2016 Amendments to Chapter 14 Subdivision Regulations

Figure No 6 - Parkway Road Section

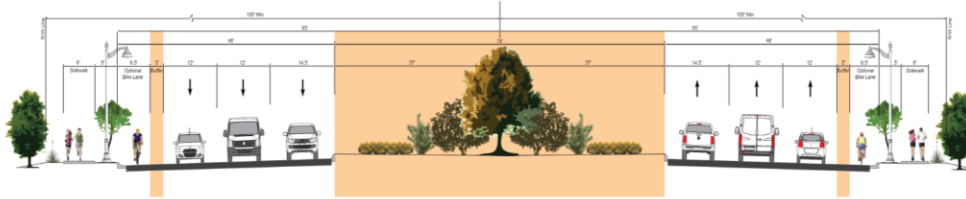
33. Sec. 14-6-8: Added Figure 6-17.

ROW Width	Median Required	Median Width	Curb Type	# of Travel Lanes	On-Street Parking Required	Bike Lane Required	Sidewalk	Landscape Strip
200'	Yes	74'	Inside vertical curb, outside vertical curb and gutter	3 travel lanes each side, plus turning lane	No	Yes	Detached	5' wide at B.O.C.

Figure No 7 - Principal Arterial I Road Section

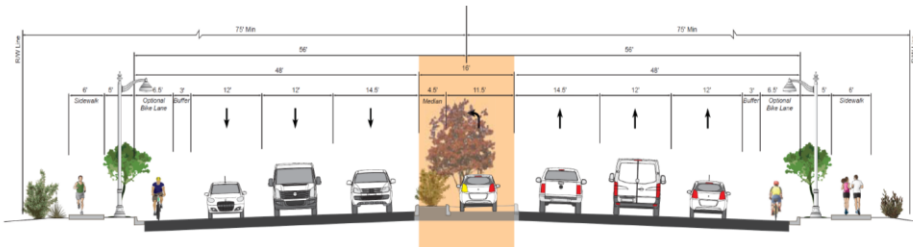
ROW Width	Median Required	Median Width	Curb Type	# of Travel Lanes	On-Street Parking Required	Bike Lane Required	Sidewalk	Landscape Strip
150'	Yes	16'	Inside vertical curb, outside vertical curb and gutter	3 travel lanes each side, plus turning lane	No	Yes	Detached	5' wide at B.O.C.

Figure No 8 - Principal Arterial II Road Section

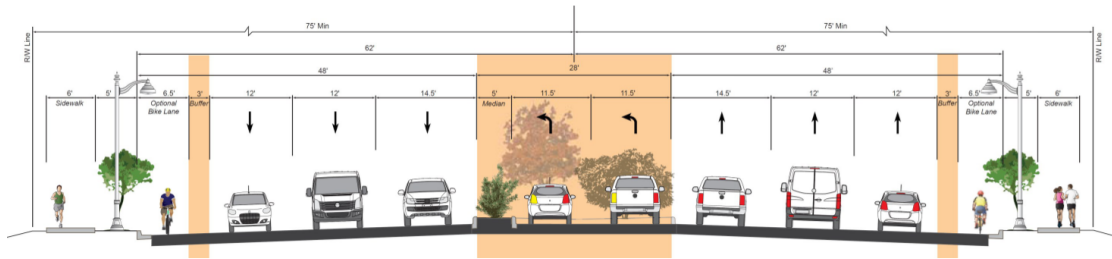
ROW Width	Median Required	Median Width	Curb Type	# of Travel Lanes	On-Street Parking Required	Bike Lane Required	Sidewalk	Landscape Strip
150'	Yes	28'	Inside vertical curb, outside vertical curb and gutter	3 travel lanes each side, plus turning lanes	No	Yes	Detached	5' wide at B.O.C.

Figure No 9 - Minor Arterial Road Section

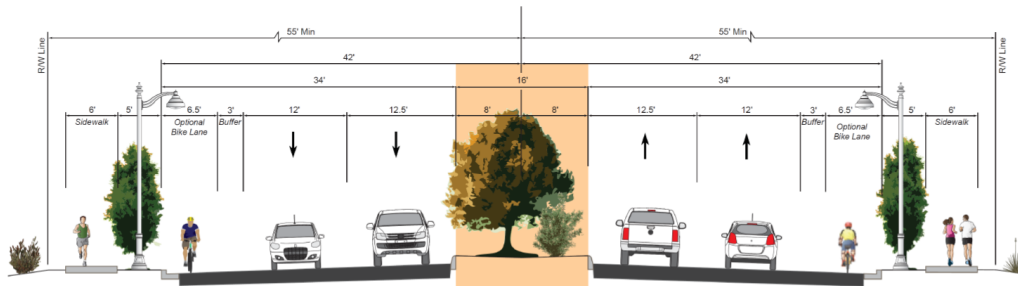
ROW Width	Median Required	Median Width	Curb Type	# of Travel Lanes	On-Street Parking Required	Bike Lane Required	Sidewalk	Landscape Strip
110'	Yes	16'	Inside vertical curb, outside vertical curb and gutter	2 travel lanes each side, plus turning lane	No	Yes	Detached	5' wide at B.O.C.

Figure No 10 - Collector Road Section

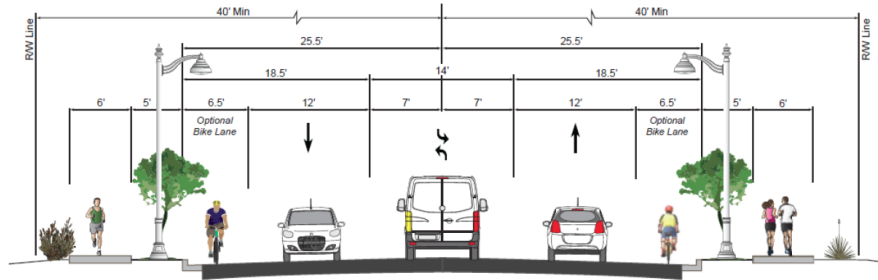
ROW Width	Median Required	Median Width	Curb Type	# of Travel Lanes	On-Street Parking Required	Bike Lane Required	Sidewalk	Landscape Strip
80'	No	n/a	Outside vertical curb and gutter	1 travel lane each side, with two way left turn	No	Yes	Detached	5' wide at B.O.C.

Figure No 11 - Village Collector Road Section (option 1)

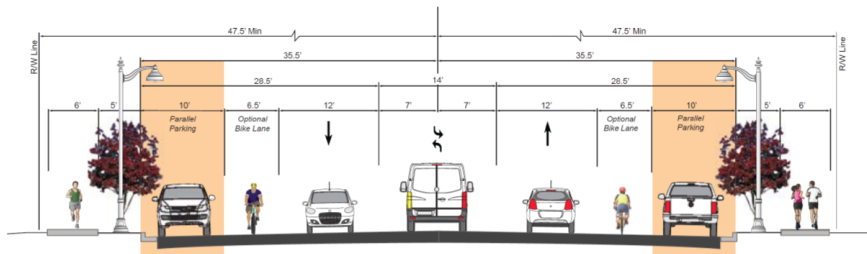
ROW Width	Median Required	Median Width	Curb Type	# of Travel Lanes	On-Street Parking Required	Bike Lane Required	Sidewalk	Landscape Strip
95'	No	n/a	Outside vertical curb and gutter	1 travel lane each side, with two way left	Yes	Yes	Detached	5' wide at B.O.C.

Figure No 12 - Village Collector Road Section (option 2)

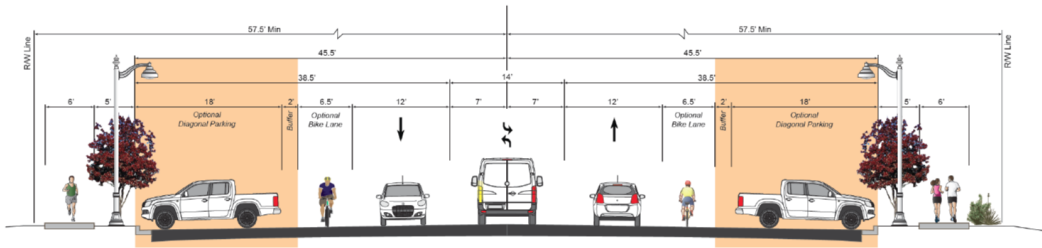
ROW Width	Median Required	Median Width	Curb Type	# of Travel Lanes	On-Street Parking Required	Bike Lane Required	Sidewalk	Landscape Strip
115'	No	n/a	Outside vertical curb and gutter	1 travel lane each side, with two way left turn	Yes	Yes	Detached	5' wide at B.O.C.

Figure No 13 - Character Area Road Section

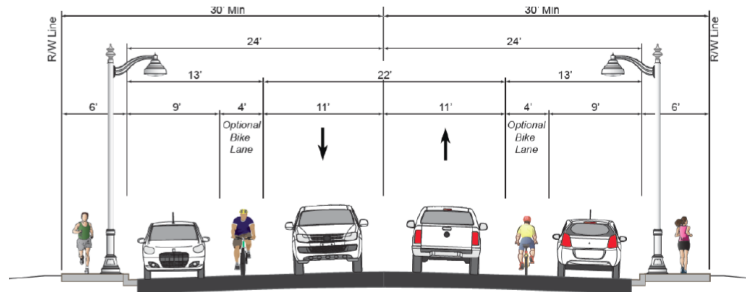
ROW Width	Median Required	Median Width	Curb Type	# of Travel Lanes	On-Street Parking Required	Bike Lane Required	Sidewalk
60'	No	n/a	Outside vertical curb and gutter	1 travel lane each side	Yes	Yes	Attached

Figure No 14 - Local Road Section (option 1)

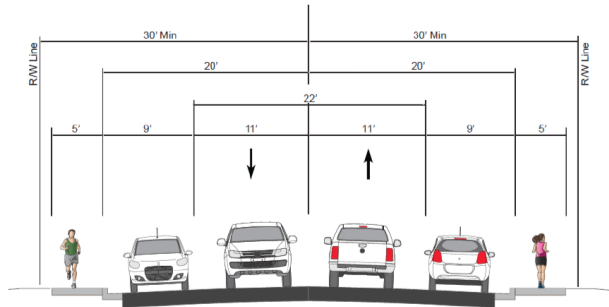
ROW Width	Median Required	Median Width	Curb Type	# of Travel Lanes	On-Street Parking Required	Bike Lane Required	Sidewalk	Landscape Strip
60'	No	n/a	Outside rolled curb and gutter (*)	1 travel lane each side	Yes	No	Attached	5' wide at B.O.W.

Figure No 15 - Local Road Section (option 2)

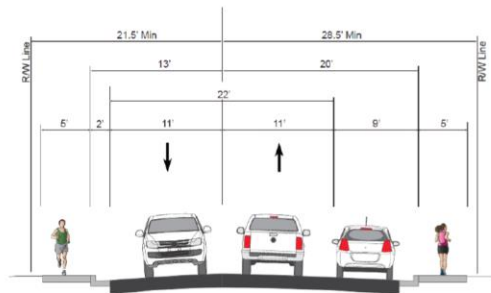
ROW Width	Median Required	Median Width	Curb Type	# of Travel Lanes	On-Street Parking Required	Bike Lane Required	Sidewalk	Landscape Strip
50'	No	n/a	Outside rolled curb and gutter (*)	1 travel lane each side	Yes, one side only(**)	No	Attached	3'6" wide at B.O.W.

Figure No 16 - Local Road Section (option 3)

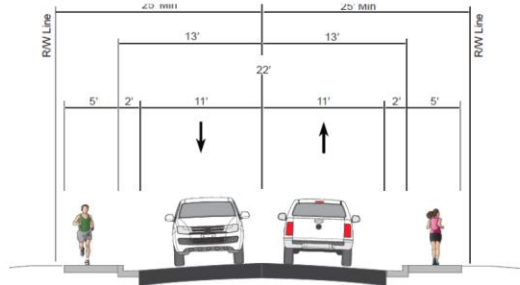
ROW Width	Median Required	Median Width	Curb Type	# of Travel Lanes	On-Street Parking Required	Bike Lane Required	Sidewalk	Landscape Strip
50'	No	n/a	Outside rolled curb and gutter (*)****	1 travel lane each side	No	No	Attached (***)	3'6" wide at B.O.W.

Figure No 17 - Industrial/Commercial Local

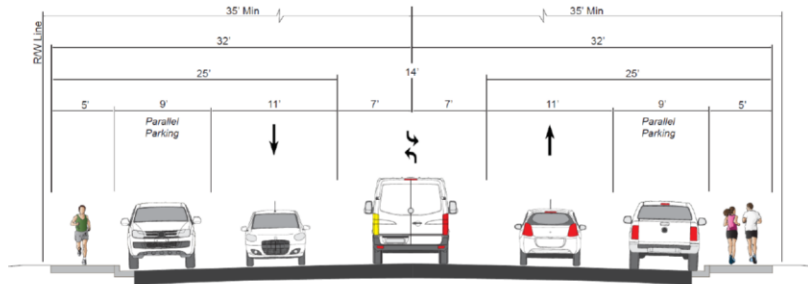
ROW Width	Median Required	Median Width	Curb Type	# of Travel Lanes	On-Street Parking	Bike Lane Required	Sidewalk	Landscape Strip
70'	No	n/a	Outside vertical curb and gutter	1 travel lane each side, with two way left turn	Yes	No	Attached	5' wide at B.O.W.
